Access Compliance Report

Public Rights-of-Way

(Curb Ramps)

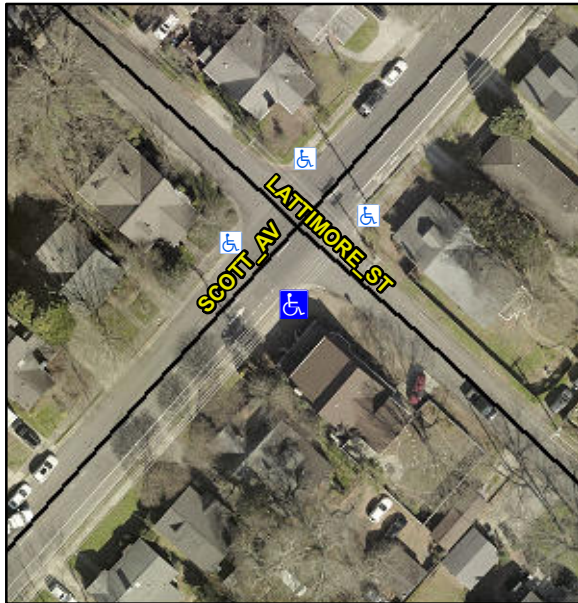
Intersection ID: 15435	Main Street: LATTIMORE_ST	Cross Street: SCOTT_AV	Location: S
ADA ID: E44FEA639423	Ramp Type: Directional1	Initial Pass/Fail: Fail	Overall Compliance: No
Severity Score: 33.75			
Codes/Mitigation Info/Possible Solution		Field Measurements/Component Compliance

R304.5.1, R304.2.2

Remove & Replace Entire Ramp.
